# UNITED STATES PATENT AND TRADEMARK OFFICE

APPLICATION NO.	FILING DATE	FIRST NAMED INVENTOR	ATTORNEY DOCKET NO.	CONFIRMATION NO.
09/920,230	08/01/2001	Jerry L. Toms	2263/101	5306

# Office Action Summary

## DETAILED ACTION

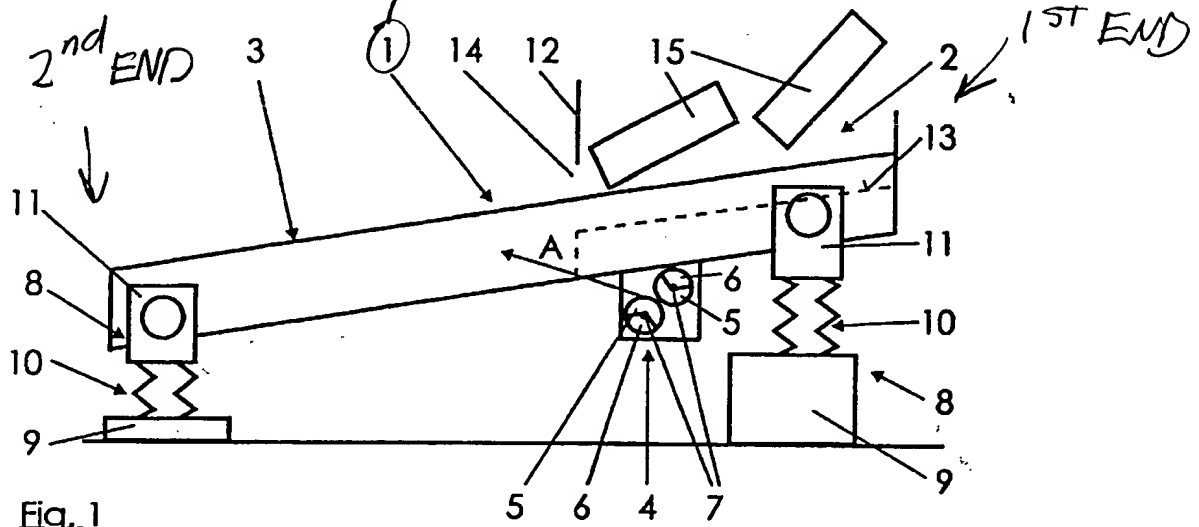
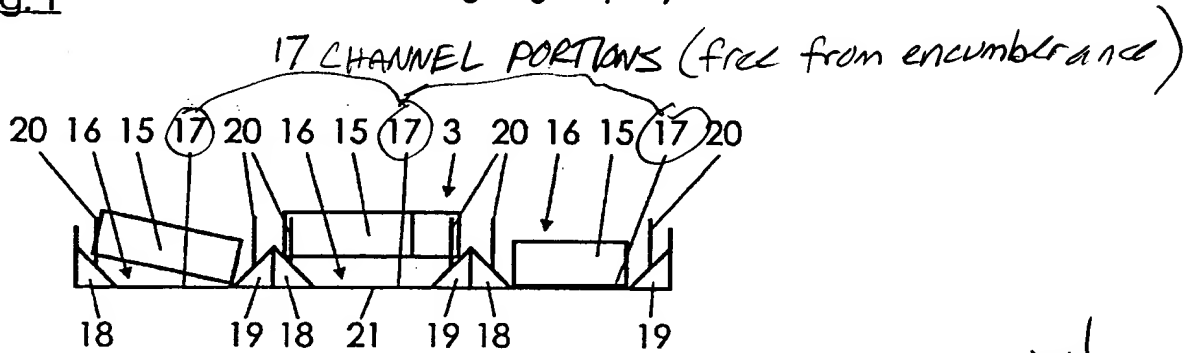
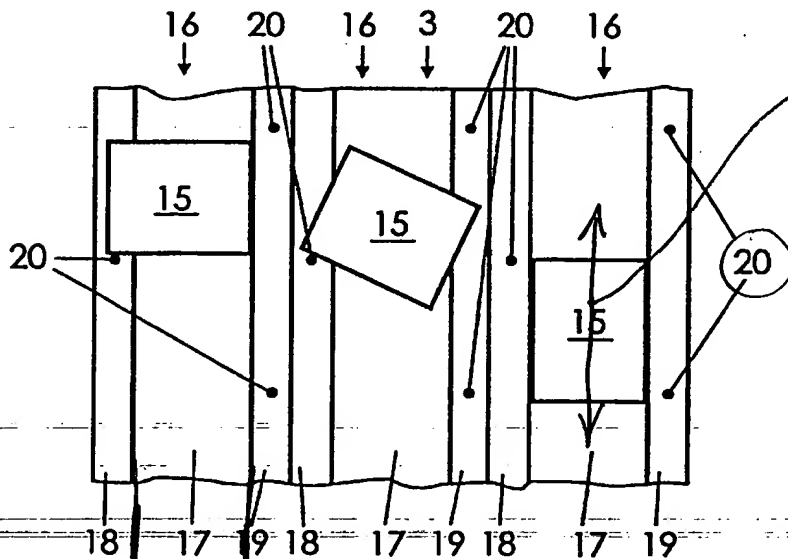
Gebhart USP 6,041,911 teaches the claimed invention as outlined on the marked up drawing figures 1-3, and the attached columns 3 and 4 of his specification. Gebhart fails to teach the staggered discharge areas of the plurality of channels. Gazzarini USP 4,026,406 teaches a feed chute having staggered discharge areas 16 as shown on the attached marked up drawing figure 1. Gebhart suggests in his column 4, that a further sorting arrangement may be arranged downstream of his particular invention which he does not show. It would have been obvious to one of ordinary skill in the art at the time the invention was made to provide an extended staggered channel configuration on the device of Gebhart as taught by Gazzarini in order to provide a further means of sorting as Gazzarini does onto his conveyor 20.

CHANNEL PORTION @ bottom member

Longitudinal Axis of Article  
Aligning means  
spaced projections

FIG. 1.

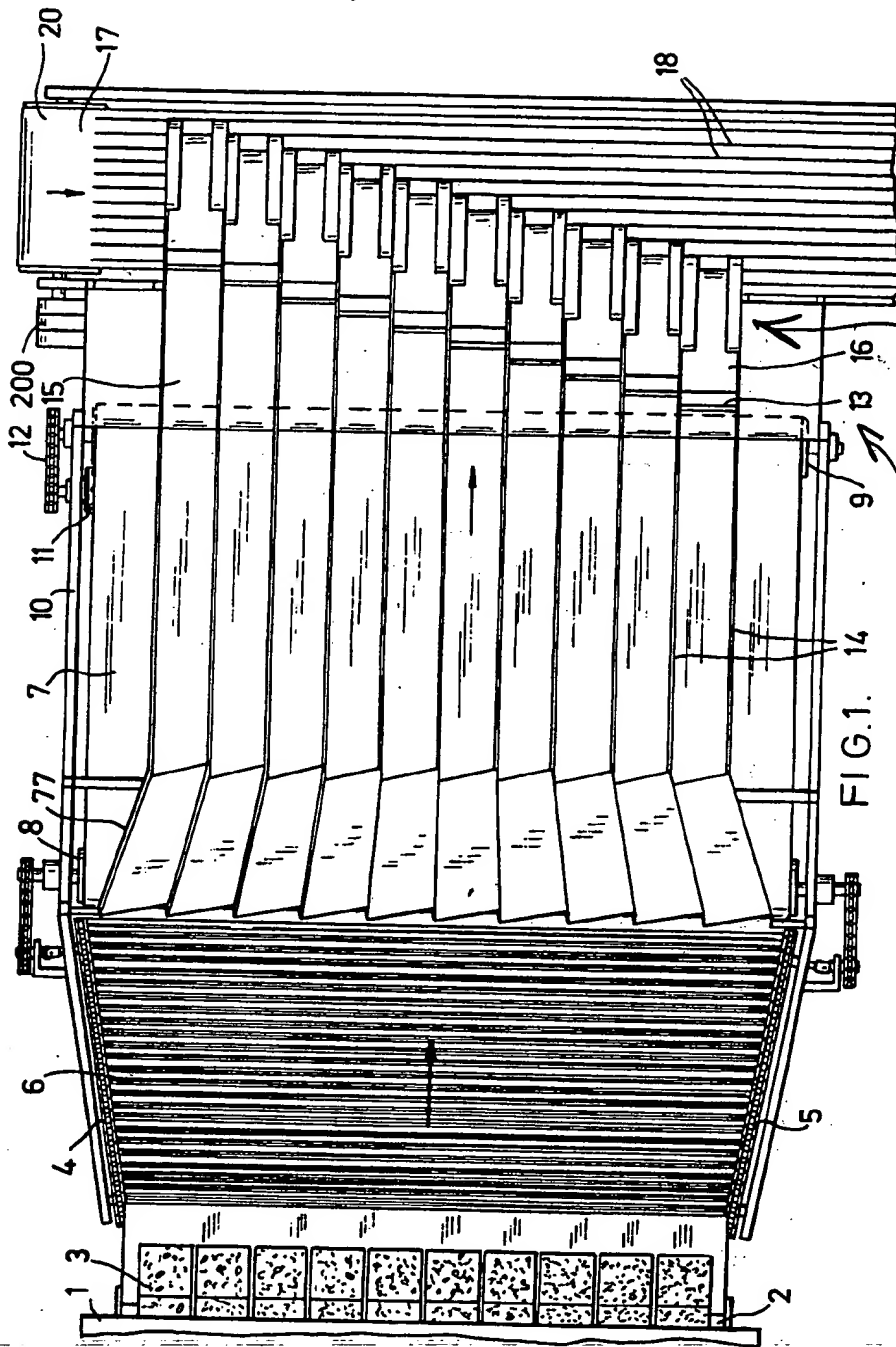
appear to be substantially the same distance (per claim 10)

Teaches the idea of staggering discharge
